GE INNOVATION POINT

Fort Point Channel Landmark District Review

October 12, 2017

DESIGN UPDATES **TABLE OF CONTENTS**

LEVEL 06 DESIGN UPDATES

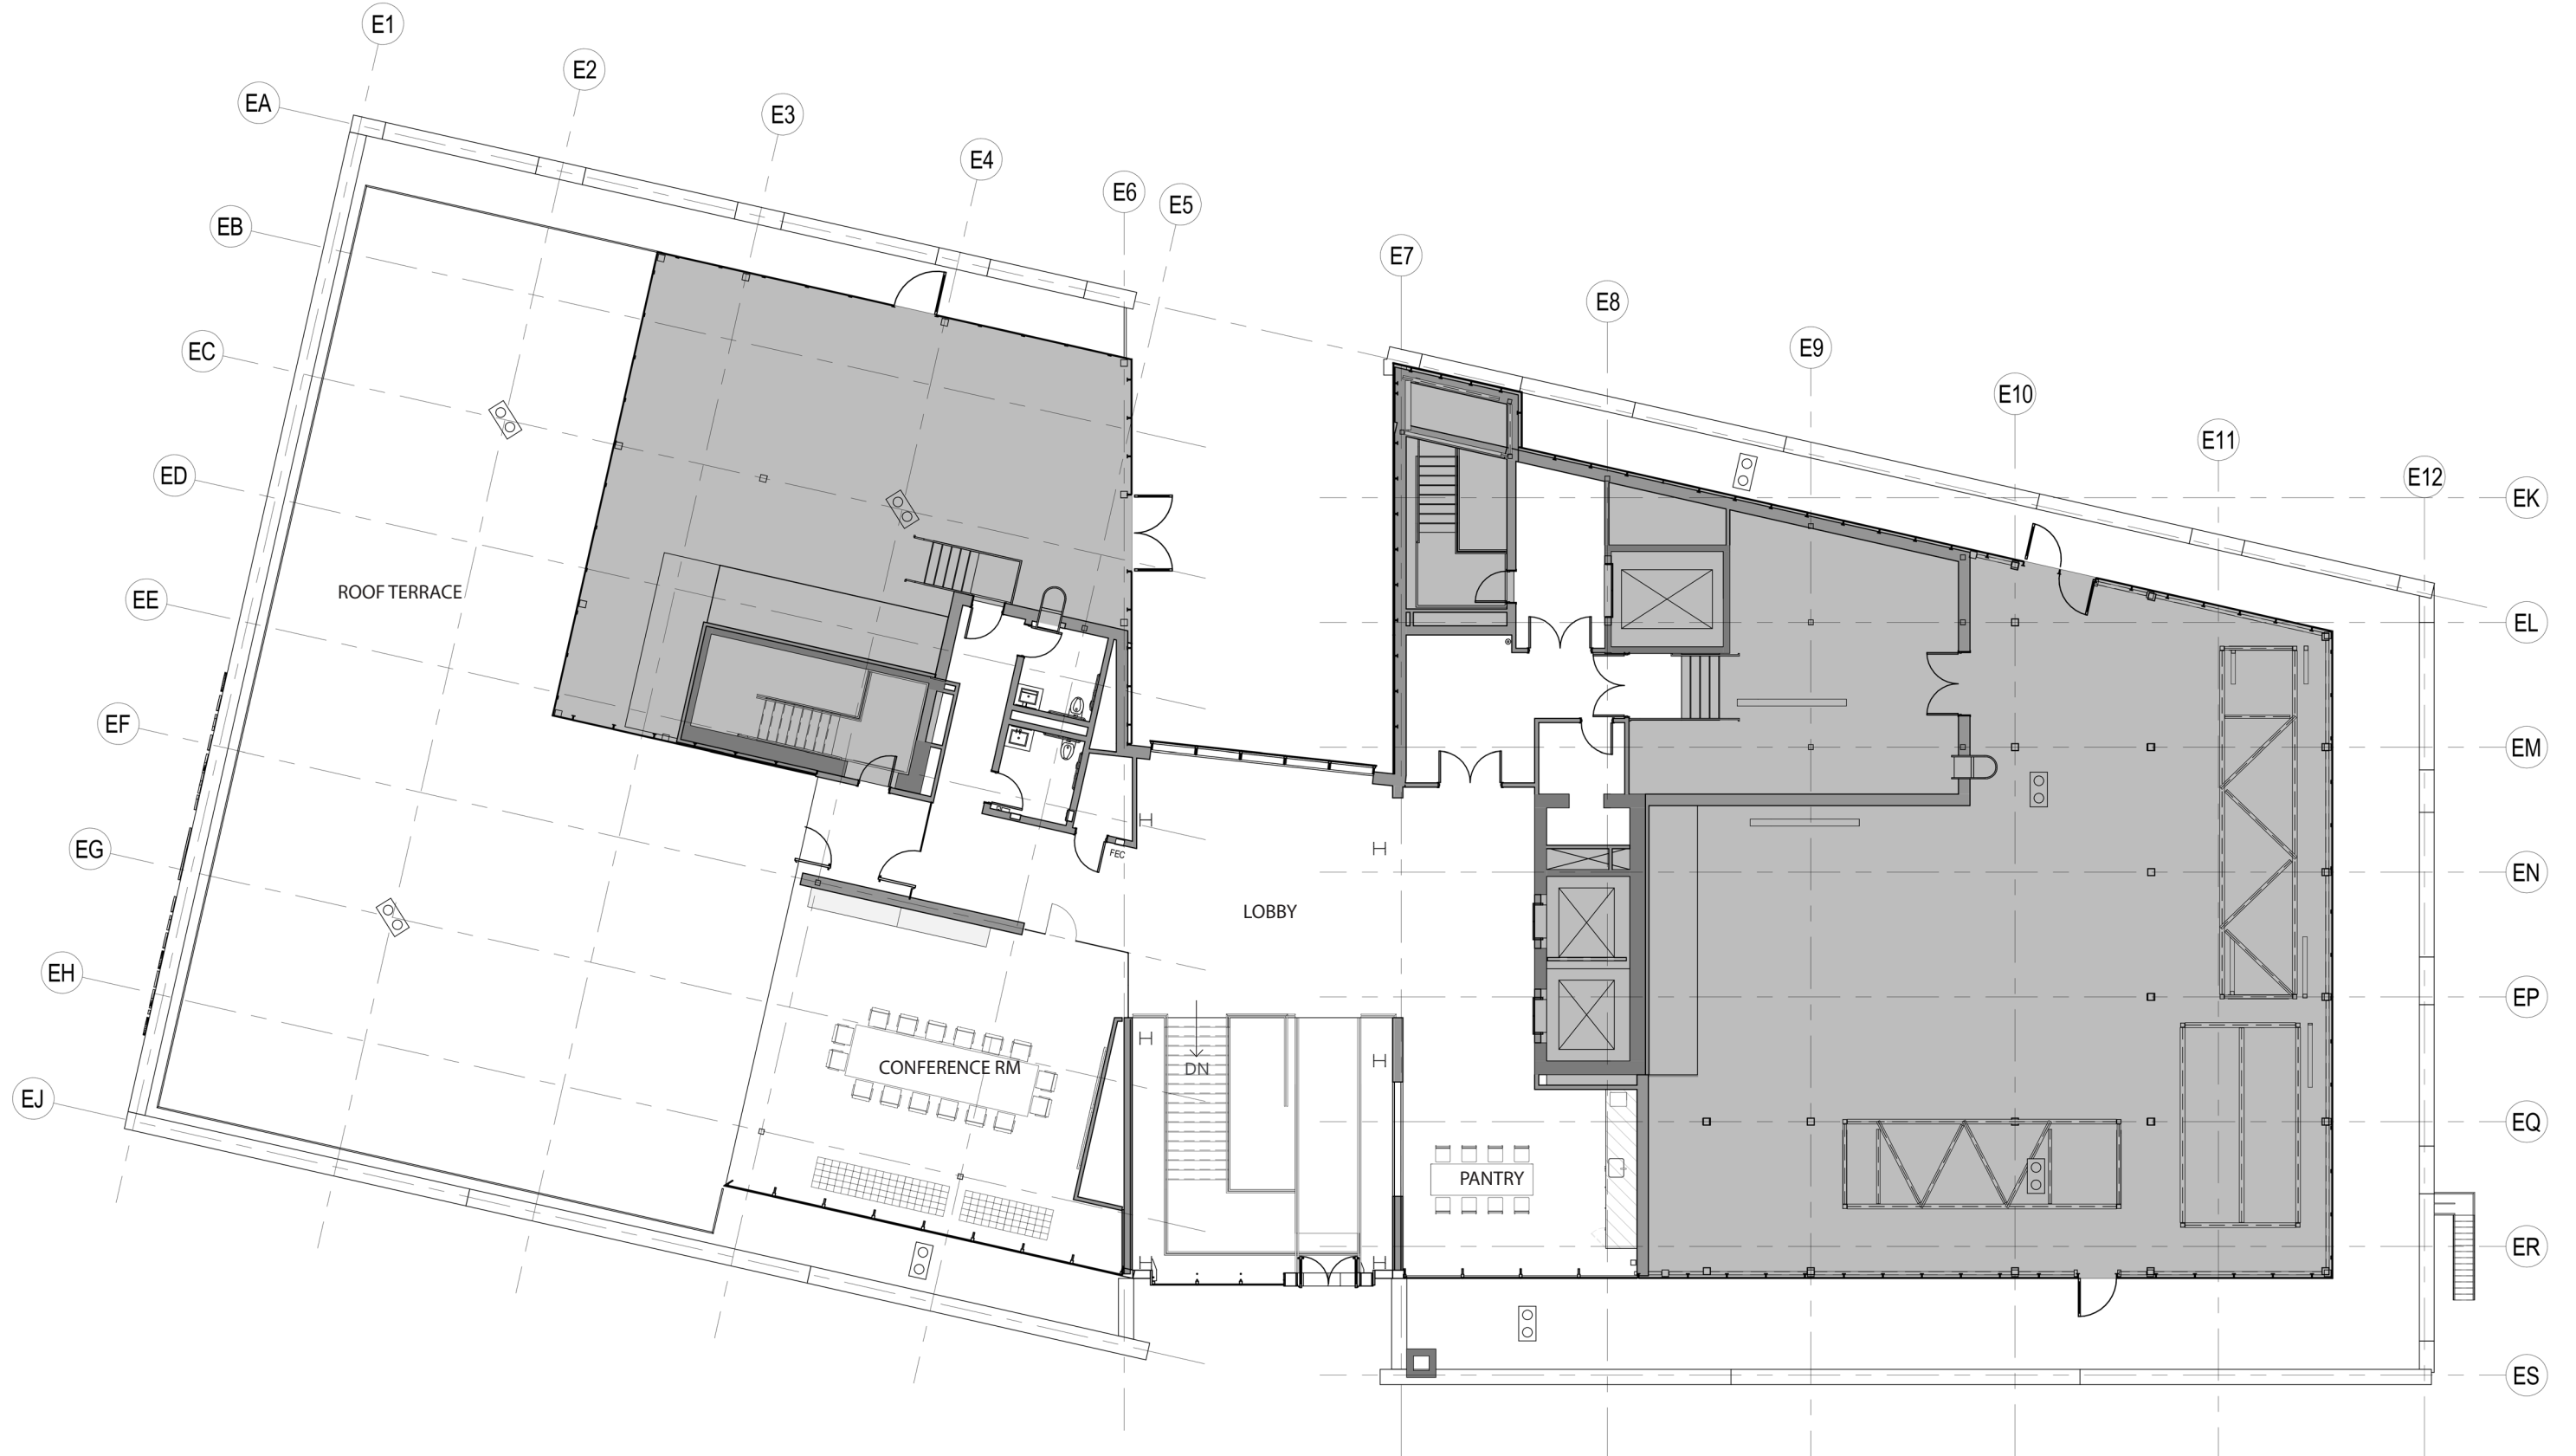
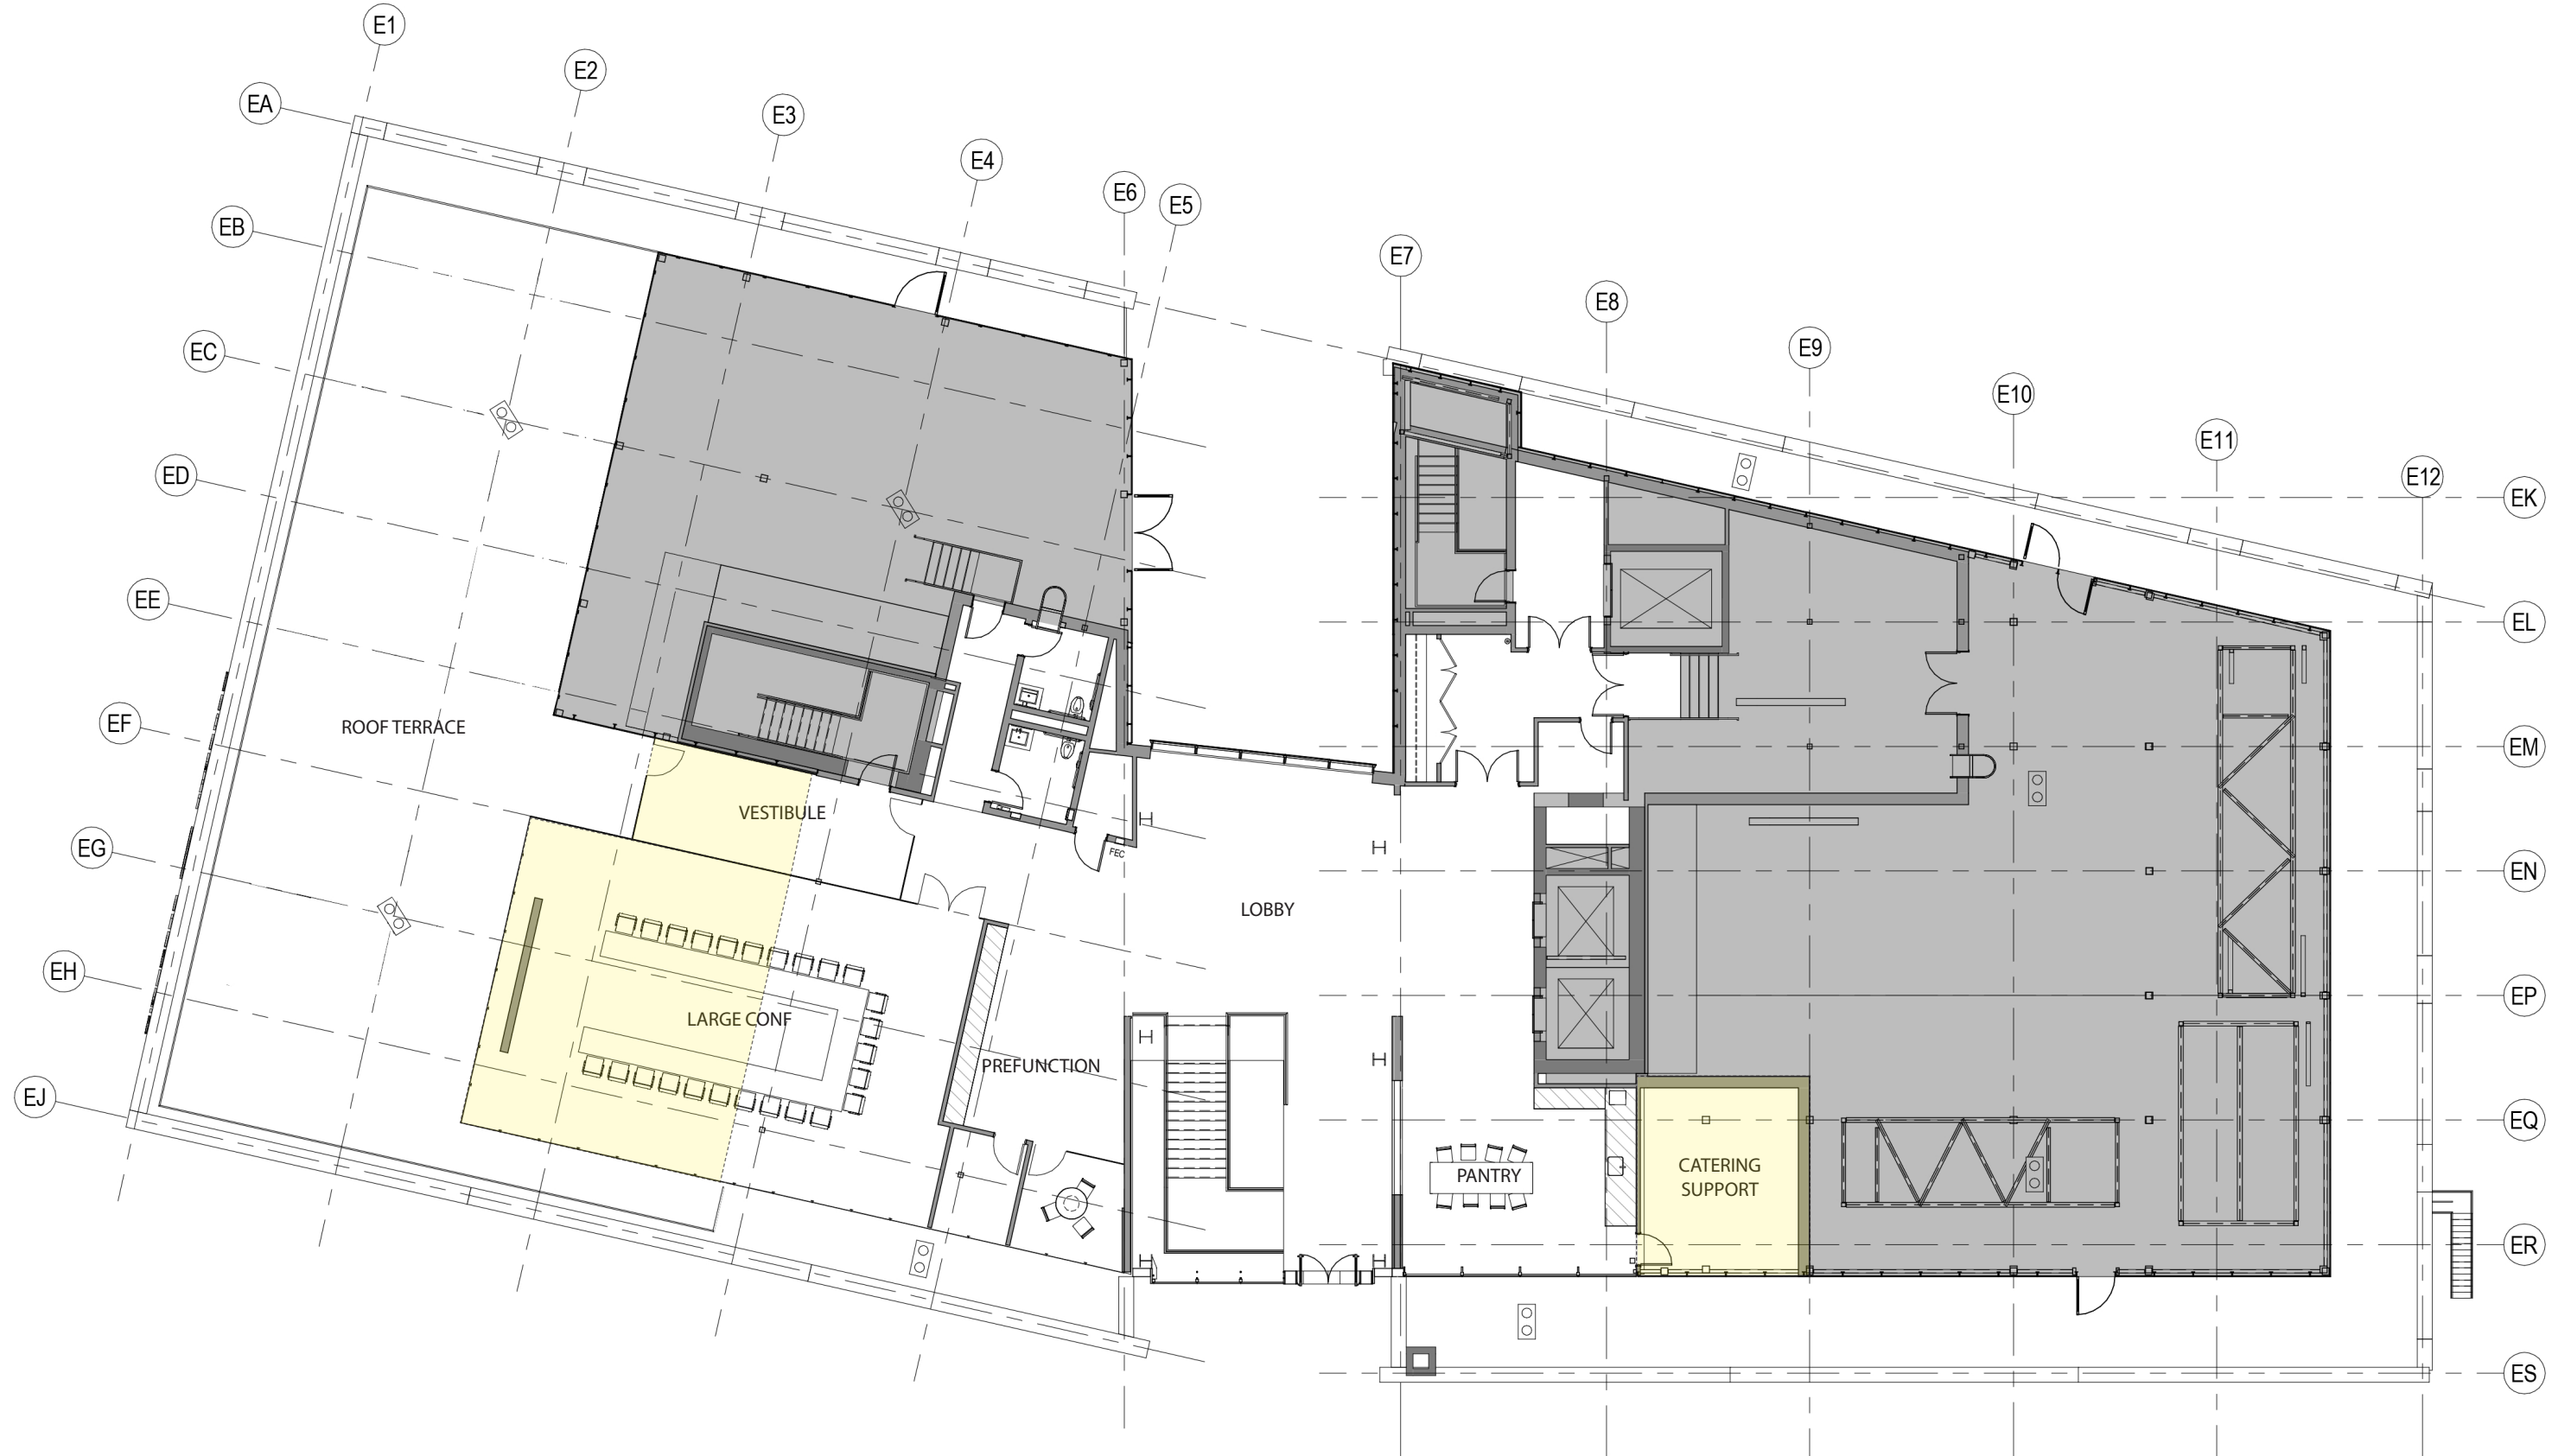
LEVEL 06 PLAN - AS APPROVED ON 2016.10.05

PROPOSED LEVEL 06 PLAN - CURRENT WITH EXPANDED CONFERENCE ROOM AND STORAGE
